Report to Planning and Environment Committee

To: Chair and Members
Planning and Environment Committee
From: Scott Mathers, MPA, P.Eng.
Deputy City Manager, Planning and Economic Development
Subject: 644-646 Huron Street, File OZ-9580, Ward 4
Public Participation Meeting
Date: May 23, 2023

Figure 2: Site concept plan (original proposal)

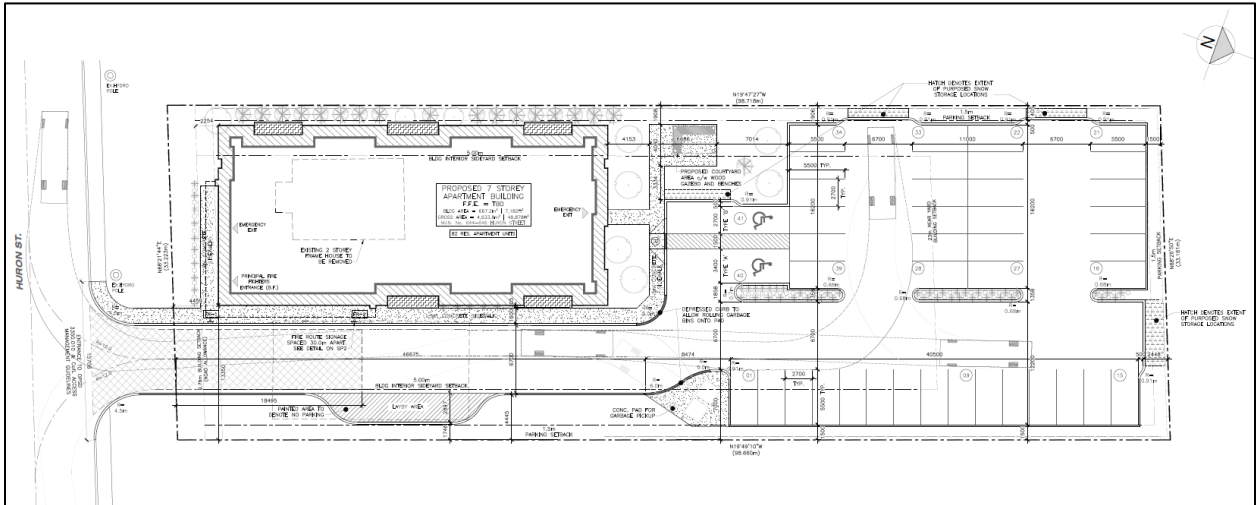
Through the review of the application, staff raised several concerns with respect to the proposed intensity and form of the site. In addition, the number of special provisions required to facilitate the proposed development were concerning, as these can often be indicative of overdevelopment. A summary of staff's initial concerns is provided below:

- The proposed 7 storey building height is not contemplated in The London Plan and exceeds both the standard maximum of 4 storeys and the upper maximum of 6 storeys, as identified in Table 11.

- Staff are not satisfied the proposed development meets the criteria in policies 1638_ to 1641_ in Our Tools (Zoning to Upper Maximum).
- Staff do not support the proposed 1.7 metre side yard setback. This setback does not provide for adequate separation and buffering between the proposed building and the adjacent property. In addition to creating negative impacts for residents of the proposed building, it may also affect the ability for the adjacent property to redevelop in the future. An appropriate side yard setback would be as follows:

- Where unit windows and balconies face the side yard: a minimum interior sideyard setback of 6m should be provided, to allow for privacy and not hinder the redevelopment of adjacent properties.

- Where no unit windows or balconies face the side yard: a minimum interior sideyard setback of 2m should be provided, to accommodate access and maintenance in the side yard.

- The site lacks an adequately sized outdoor amenity area, which is further reflected in the requested reduction in landscape open space.
- A minimum step-back of 2 metres above the 3rd or 4th storey along the street frontage should be provided to create a pedestrian scale interface.

- The parking area is in an awkward configuration that lacks functionality.

Figure 4: Site concept plan (revised proposal)

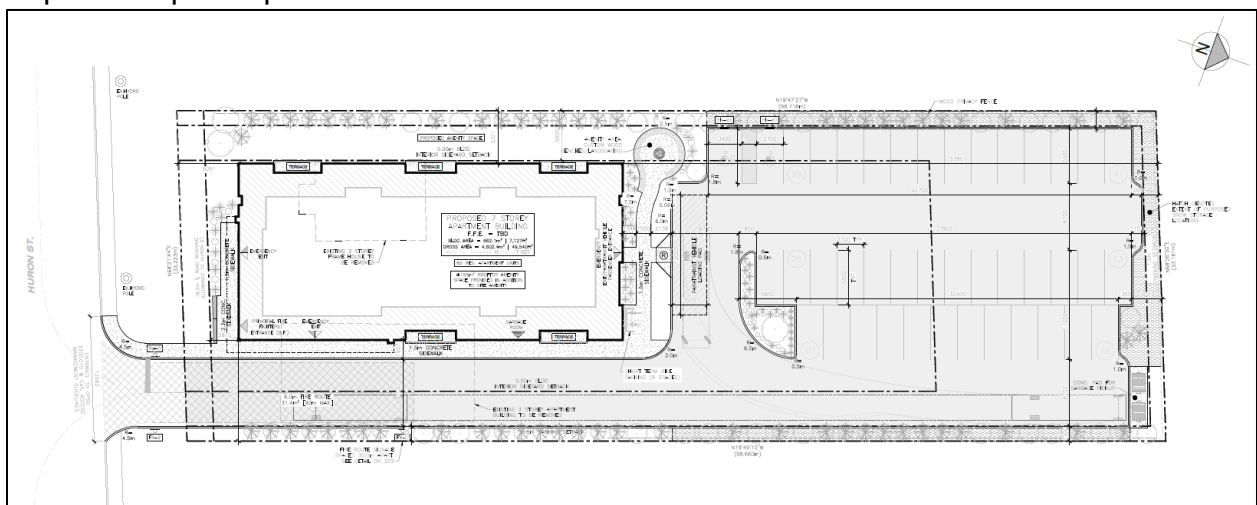
In response to the above noted concerns, the applicant provided a revised site concept plan and rendering which are depicted in Figures 4 and 5. The amended application requests a Residential R8 Special Provision (R8-4(_)) Zone, with the following special provisions:

- A reduced minimum front yard depth of 2.5 metres (whereas a minimum of 8 metres is required);
- A reduced minimum interior side yard depth of 5 metres (whereas a minimum of 8 metres is required);
- A reduced minimum landscape open space of 29% (whereas 30% is required);
- An increased maximum building height of 23 metres (whereas a maximum of 13 metres is permitted);
- An increased maximum density of 250 units per hectare (whereas a maximum of 75 units per hectare is permitted).

The revised development proposal provides for a larger interior side yard depth of 5 metres, whereas 1.7 metres was previously proposed. The minimum 1.5 metre parking area setbacks to interior lot lines has been met and no longer requires a special provision.
